Planning Application: 2560320 (Galway City Council)

Location of Development: Ragoon, Knocknacarra, Galway

Fig 2. Key Plan – Example of lands highlighted in blue “lands in applicants ownership”.

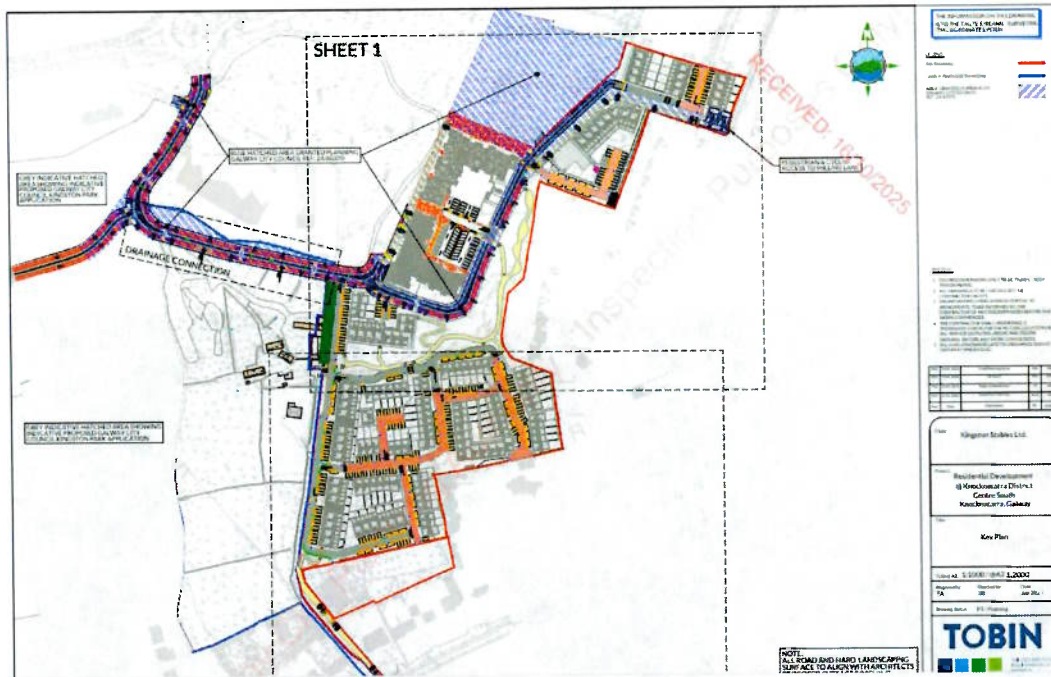
Within these documents, certain adjoining lands are identified with a blue line and described as “lands in applicant’s ownership.” However, these lands are not within the ownership or control of the applicant. While these lands are not included within the red line application boundary, I believe it is important that the documentation accurately reflects land ownership interests in the interests of clarity and proper planning. (See Fig 2 for example)
